LiDAR Quality Assessment Report

SD_MORiver-Dewberry_2016-Block6

NGTOC

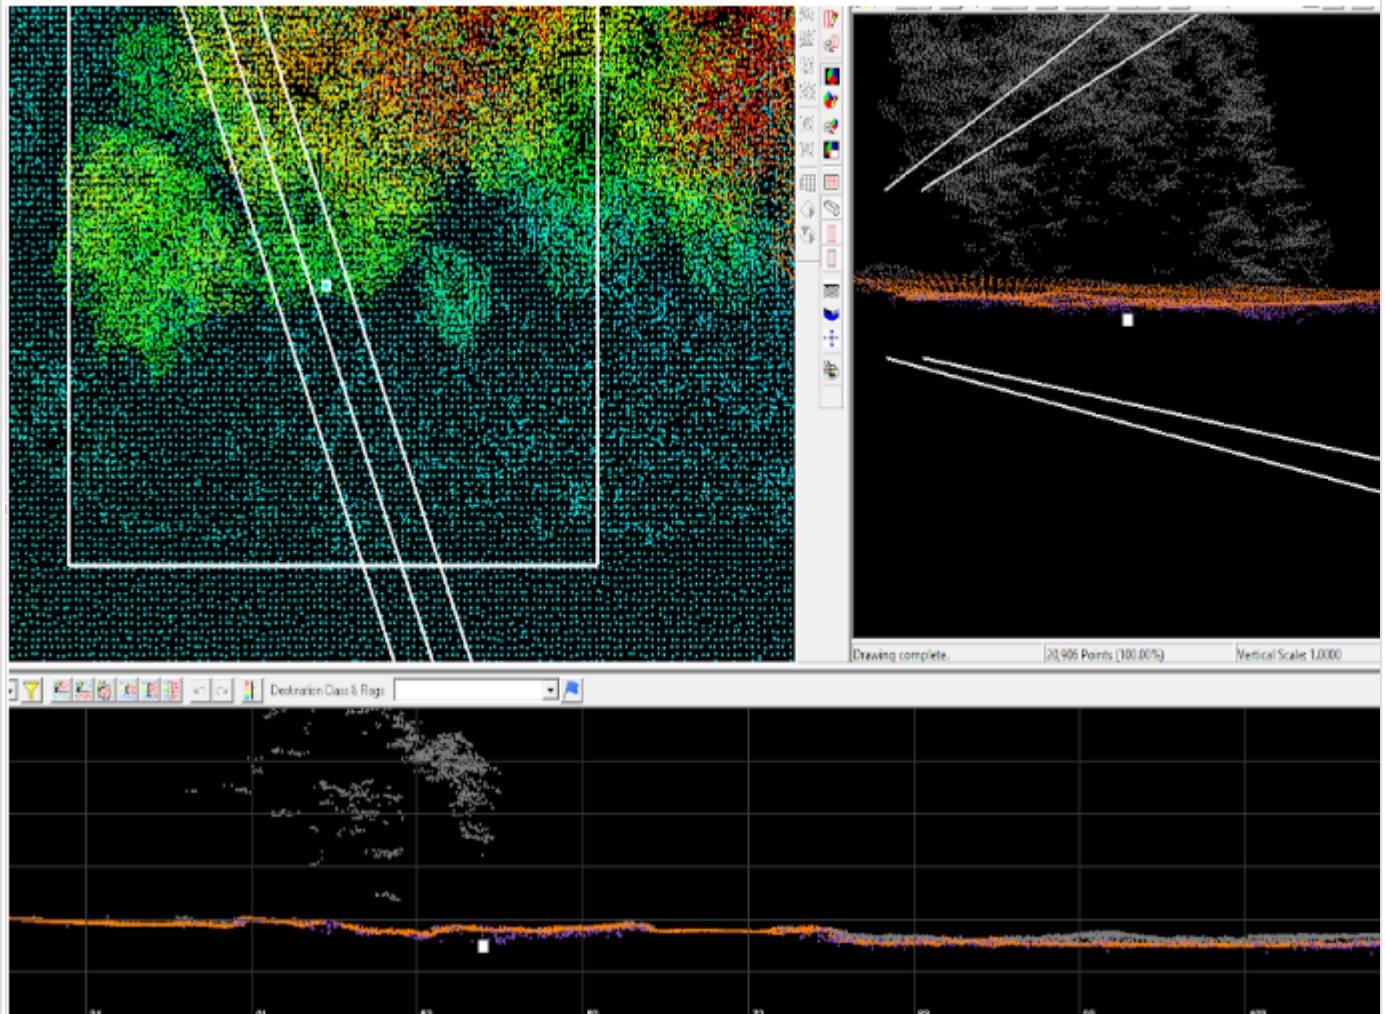
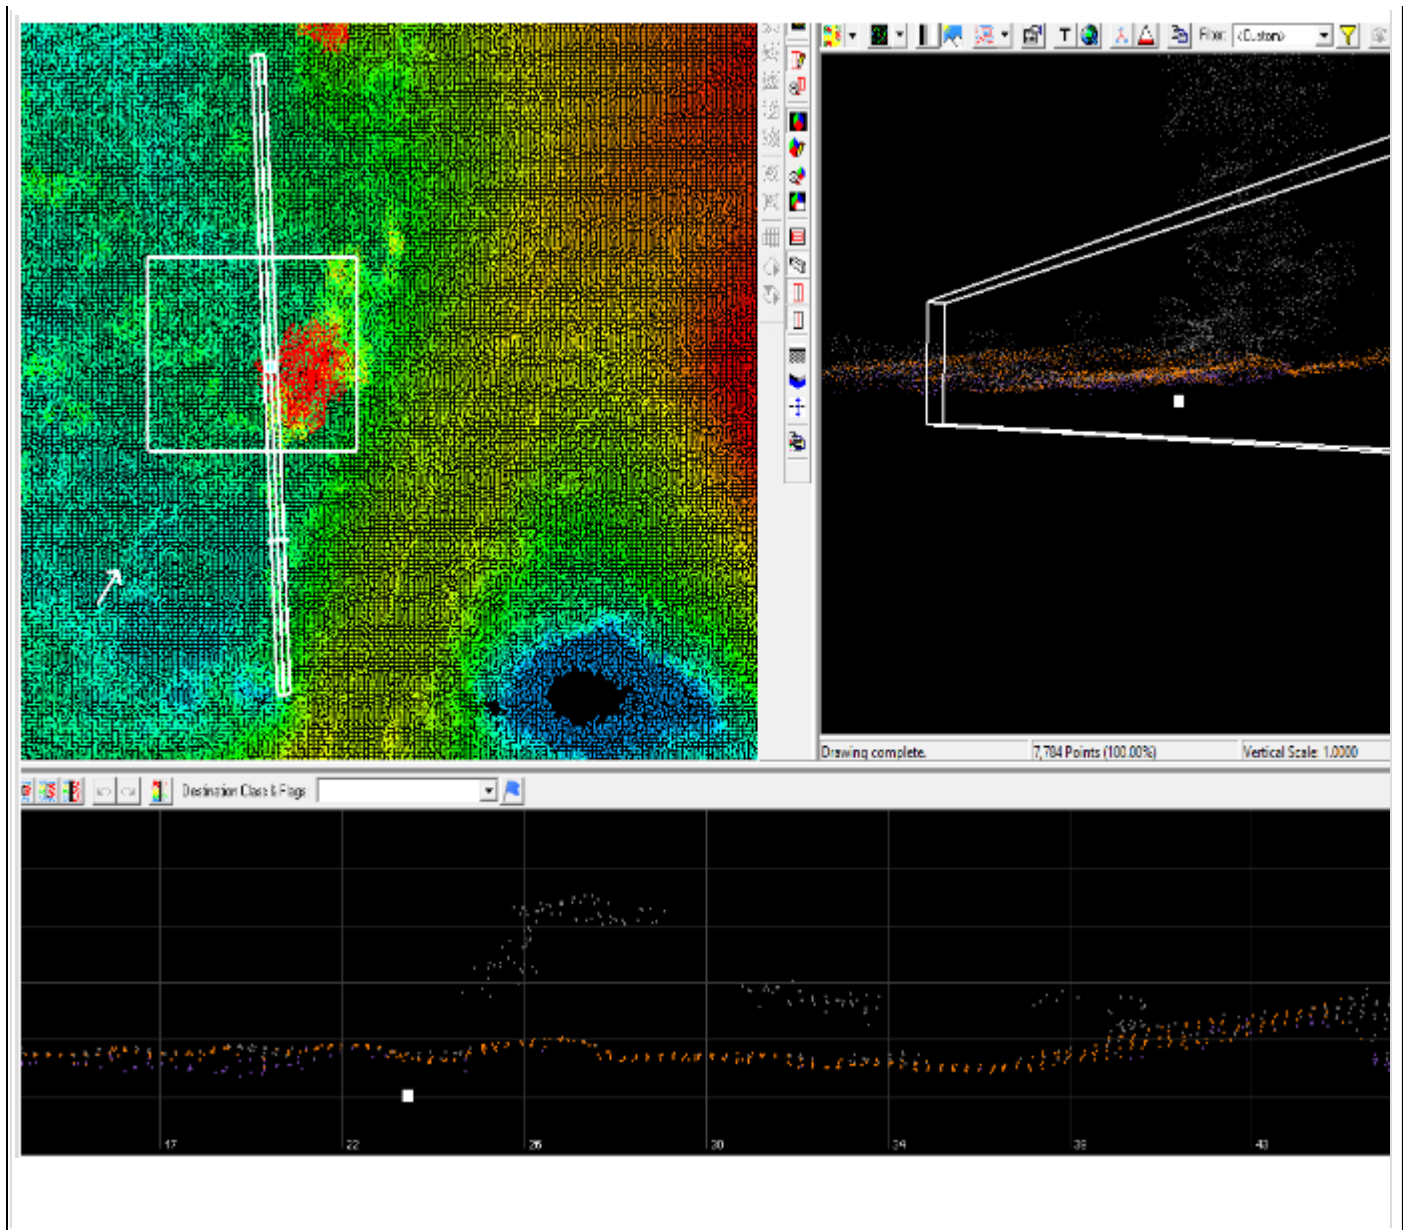
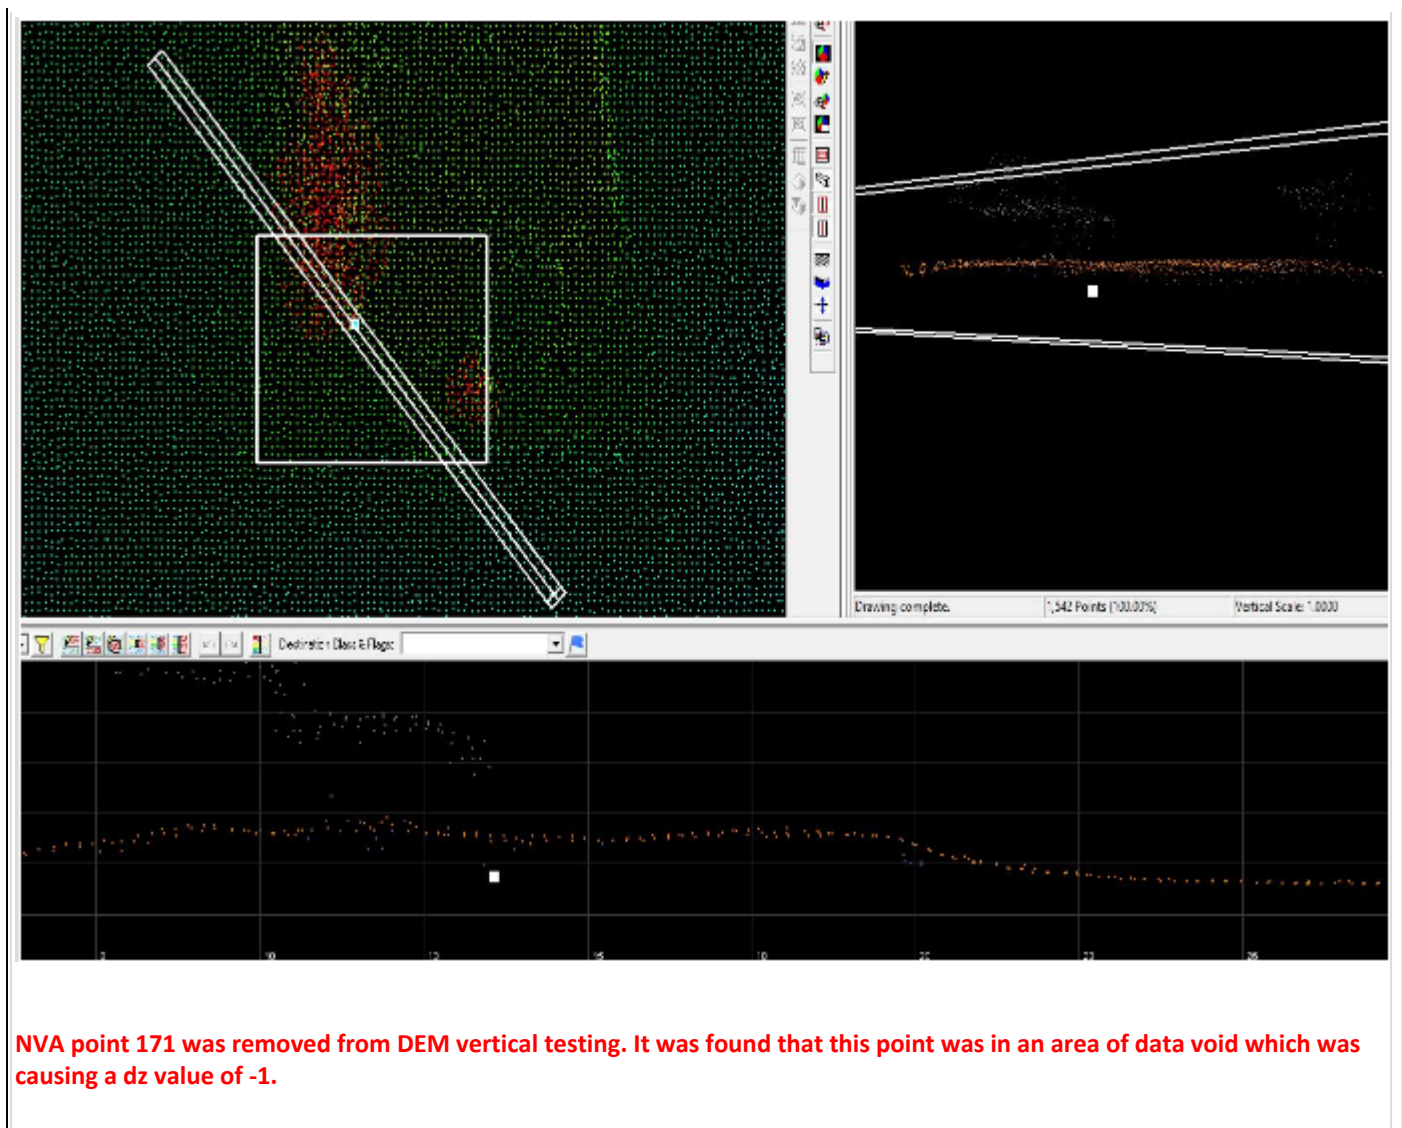
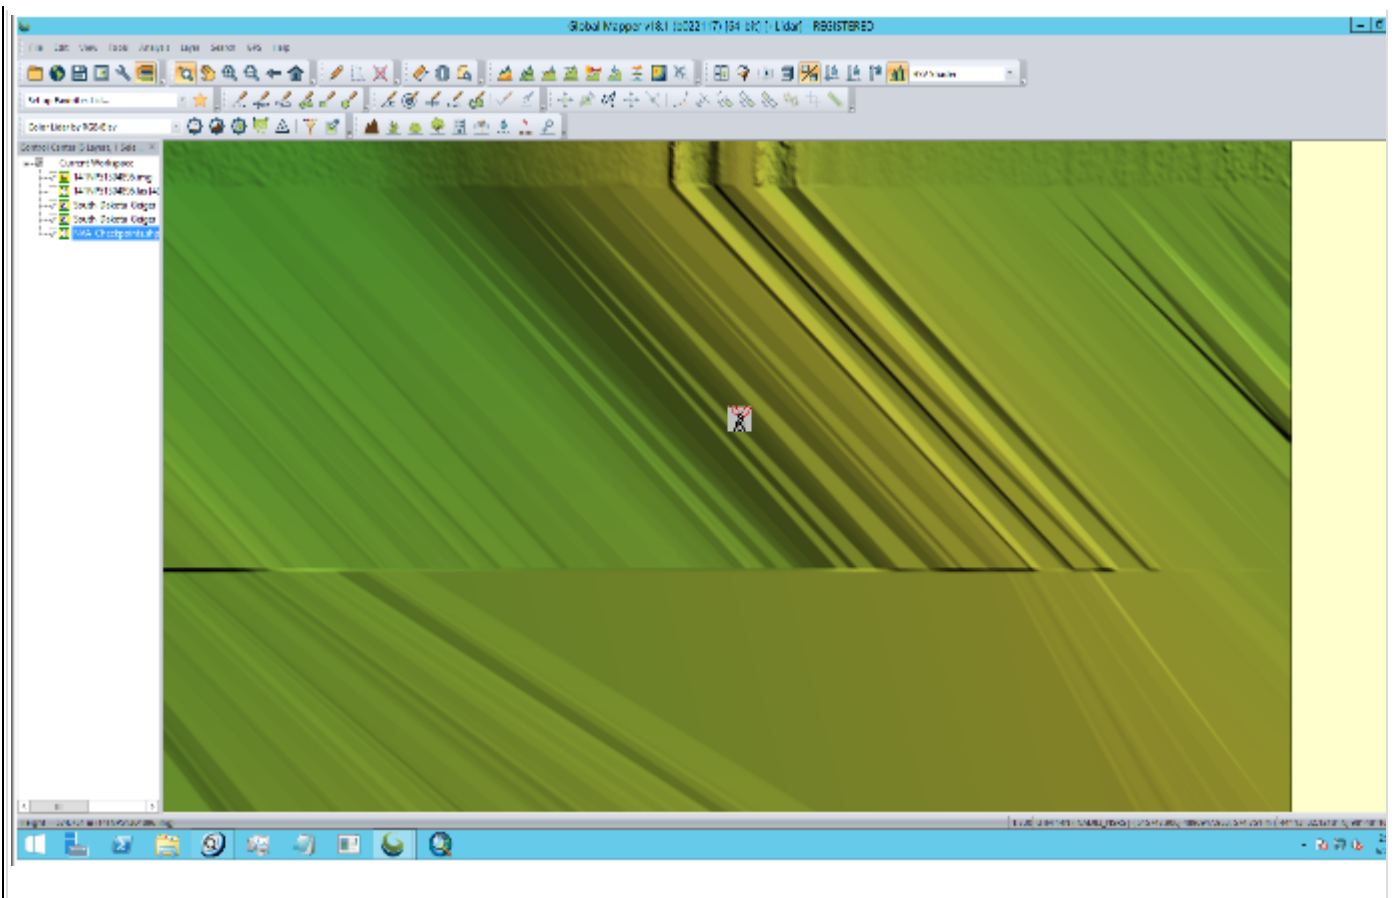
VVA testing failed to meet USGS specifications. Three of the worst points are pictured below, showing the checkpoint below the ground surface.

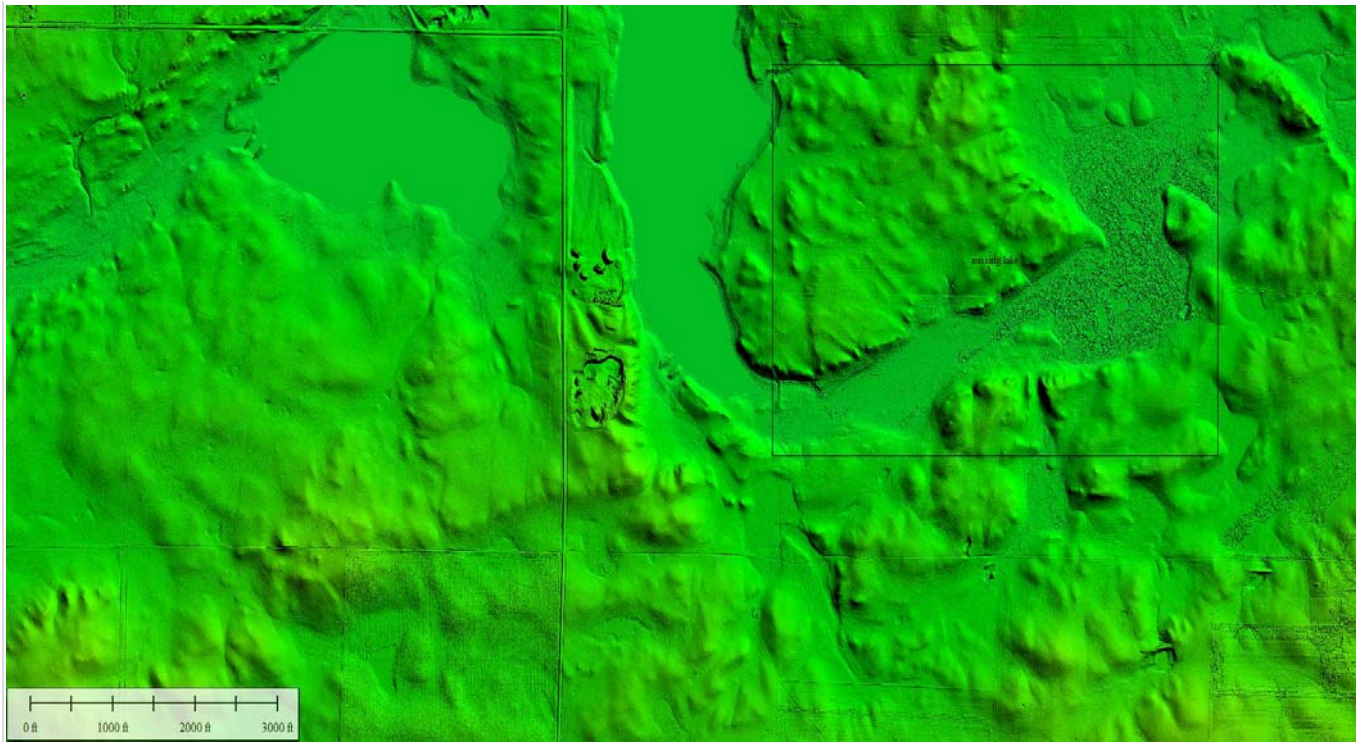
There are several ponds/lakes that were classified as ground in full or partially, and a few water bodies need to be hydroflattened. See error shapefile for examples found. There are possible more that were not found during DEM review.
